Addendum No. 1

Contract No.: DA00153

Rehab to Existing Emergency Ferry Ramp at Rodanthe in Dare County.

DOLPHIN DETAILS
 (TYPE B)

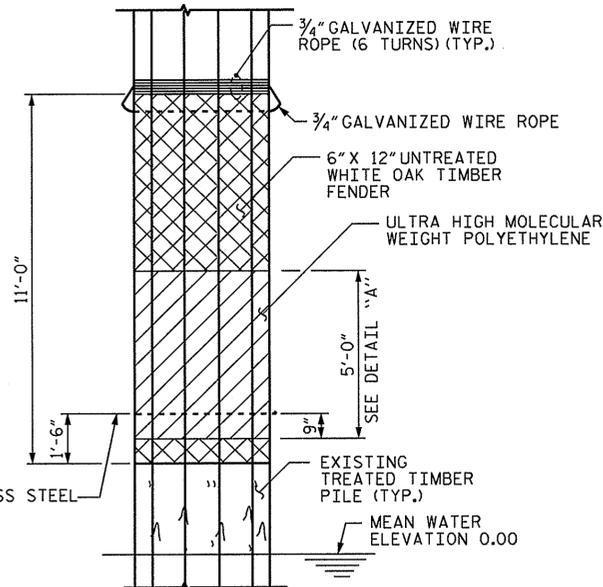
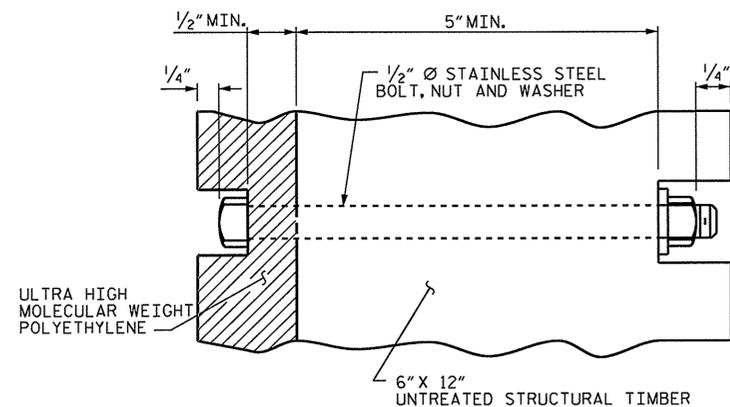
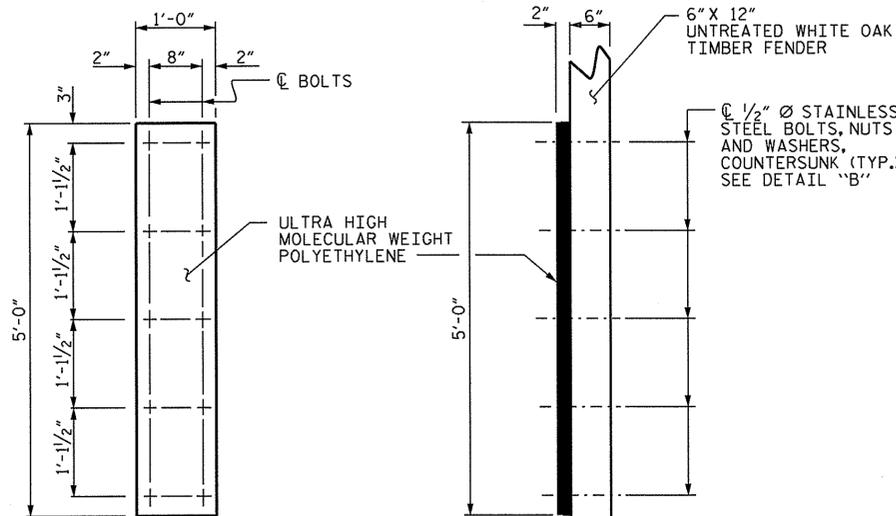
Plan Sheet S-12 "Dolphin Details Type-B" has been revised to change the proposed $\frac{3}{4}$ " galvanized steel wire rope, located at the bottom portion of the dolphin, to $\frac{1}{2}$ " stainless steel wire rope. Please void the existing Plan Sheet S-12 "Dolphin Details Type-B" in the proposal and staple revised Plan Sheet S-12 "Dolphin Details Type-B" thereto.

STAINLESS STEEL WIRE ROPE USED FOR INSTALLING UNTREATED WHITE OAK TIMBER FENDERS SHALL CONFORM TO ASTM A368.

STATE OF NORTH CAROLINA DEPARTMENT OF TRANSPORTATION RALEIGH					
ELECTRICAL LAYOUT					
RODANTHE FERRY BASIN					
REVISIONS					
NO.	BY:	DATE:	NO.	BY:	DATE:
1	LVB	3/12/13	3		
2			4		
					SHEET NO.
					TOTAL SHEETS

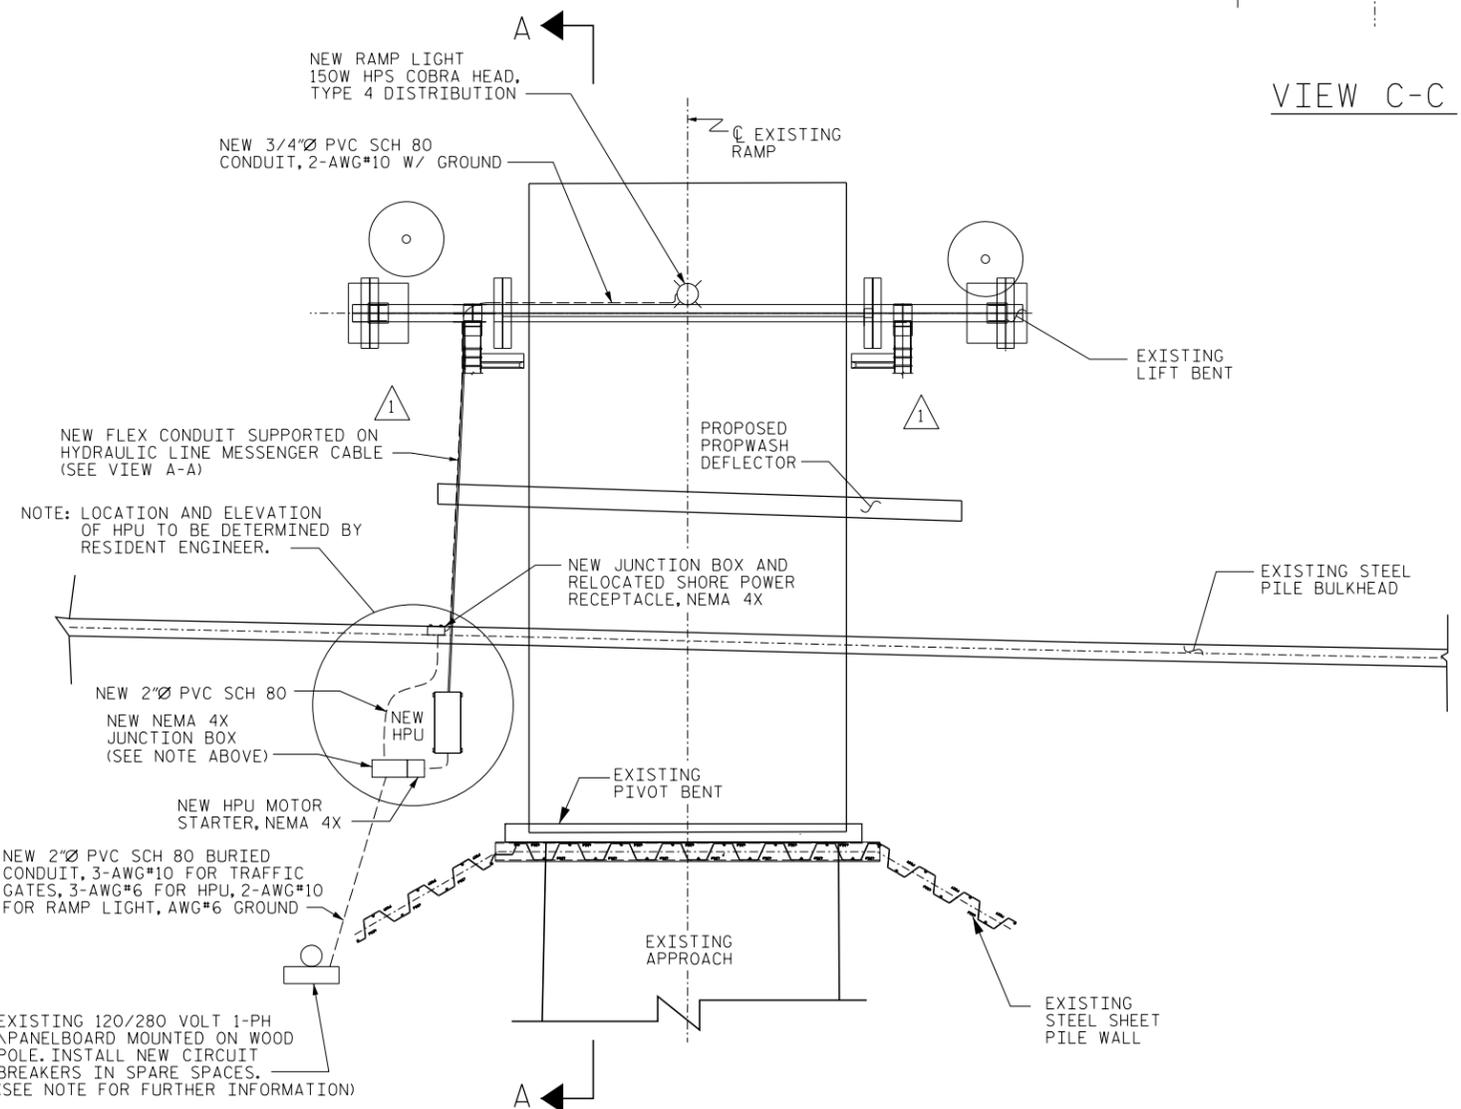
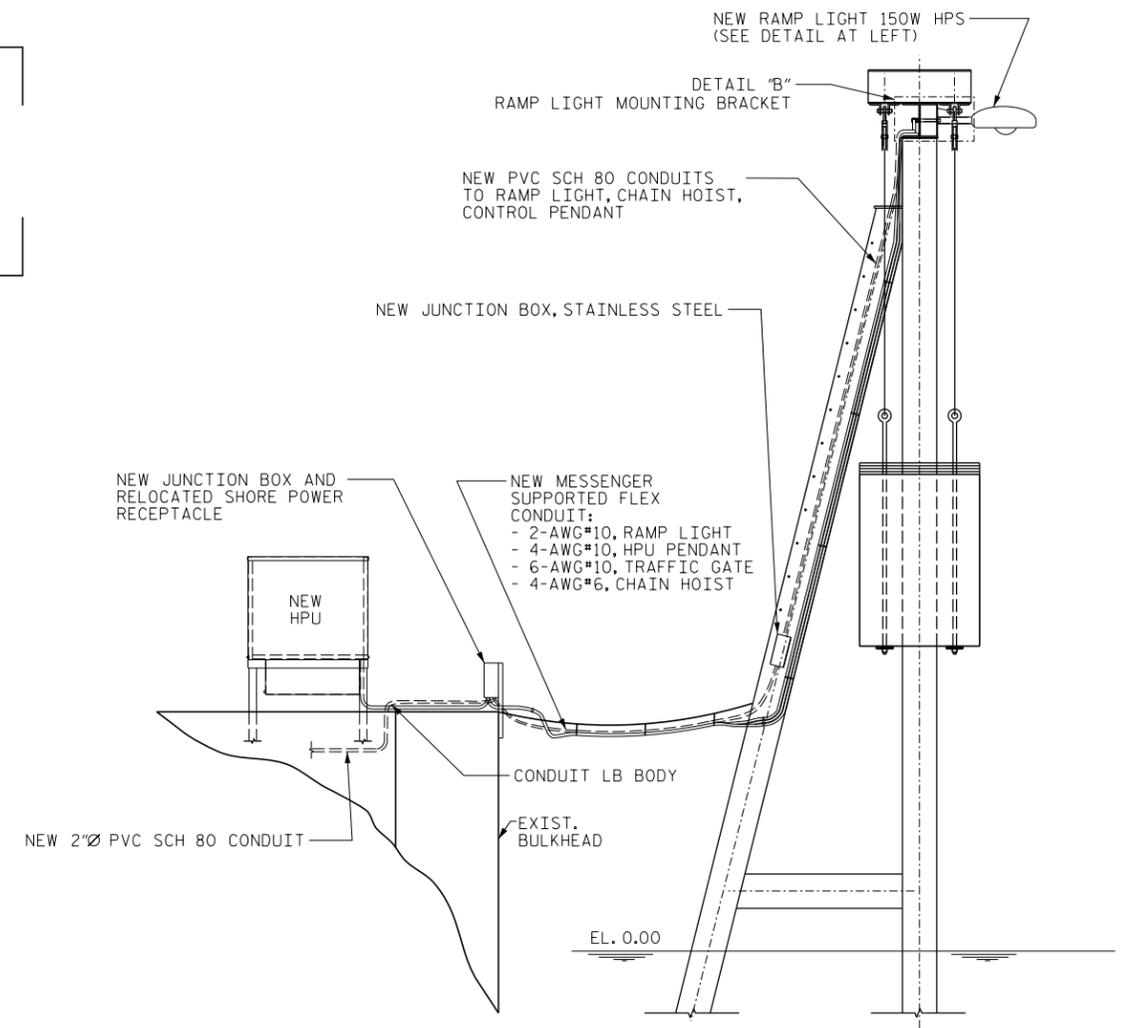
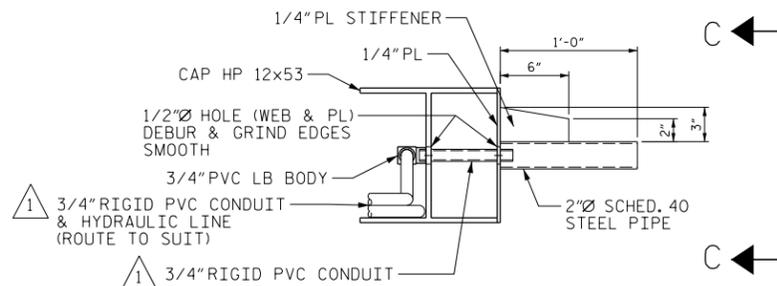
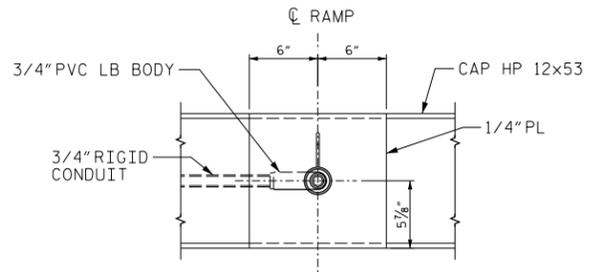
Plan Sheet "Electrical Layout" has been revised to clarify rigid conduit to be PVC and remove extraneous callout. Please void the existing Plan Sheet "Electrical Layout" in the proposal and staple revised Plan Sheet "Electrical Layout" thereto.

- 1 CLARIFIED RIGID CONDUIT TO BE PVC; REMOVED EXTRANEOUS CALLOUT.

CONTROL
PENDANT DETAILS

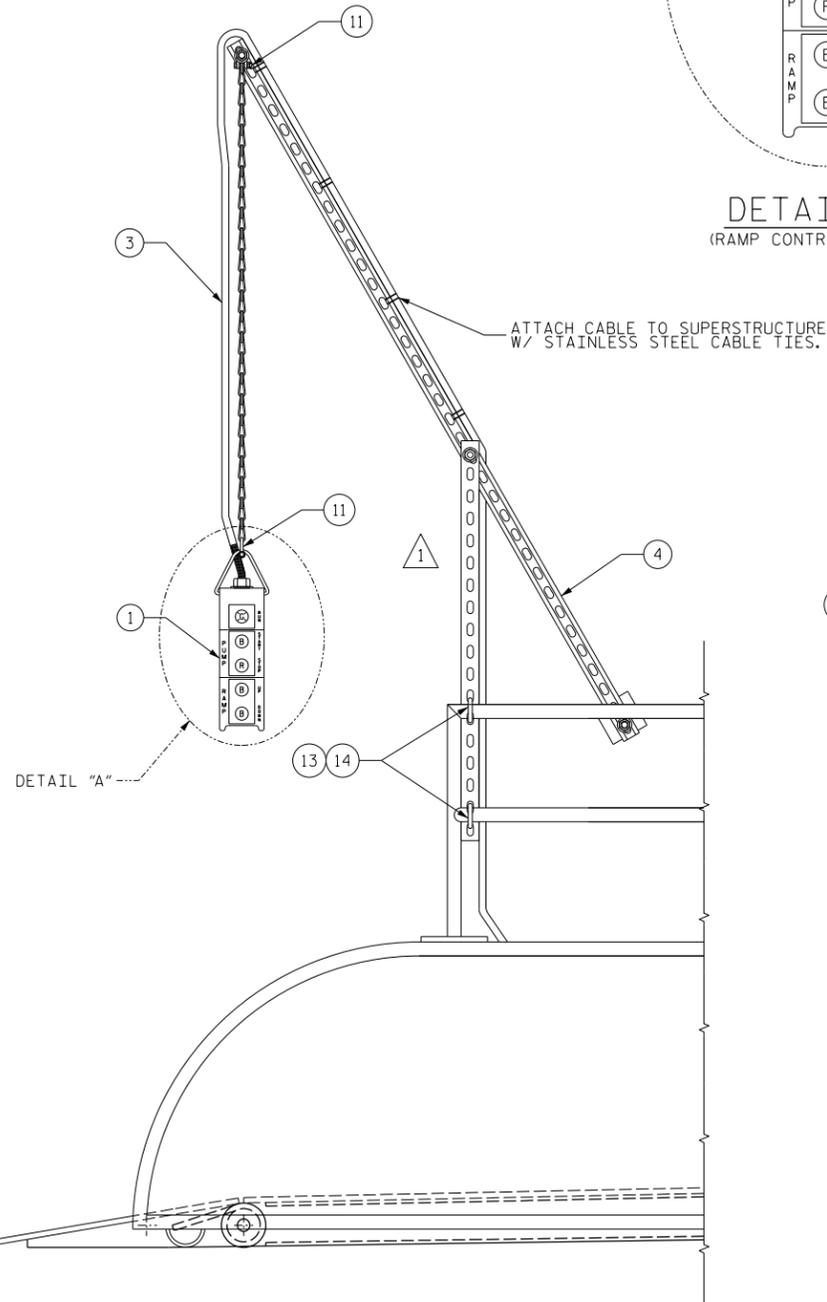
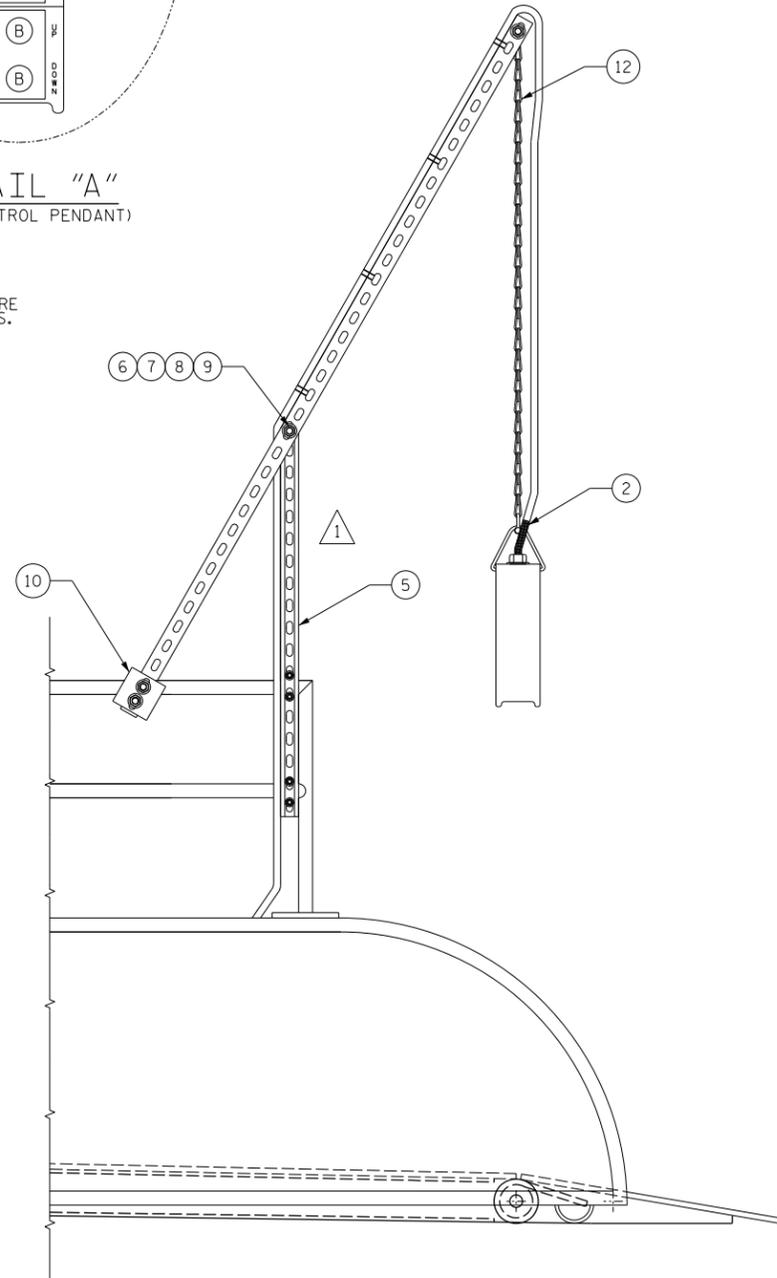
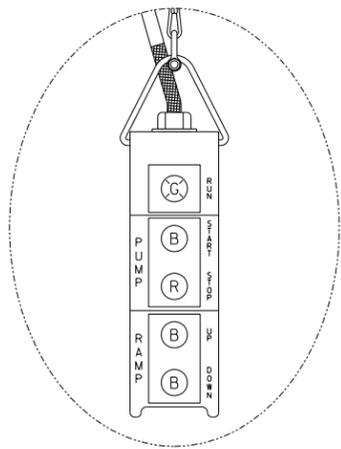
Plan Sheet "Control Pendant Detail" has been revised to eliminate the traffic gate control pendant. Please void the existing Plan Sheet "Control Pendant Detail" in the proposal and staple revised Plan Sheet "Control Pendant Detail" thereto.

- 1 REMOVED TRAFFIC GATE CONTROL PENDANT
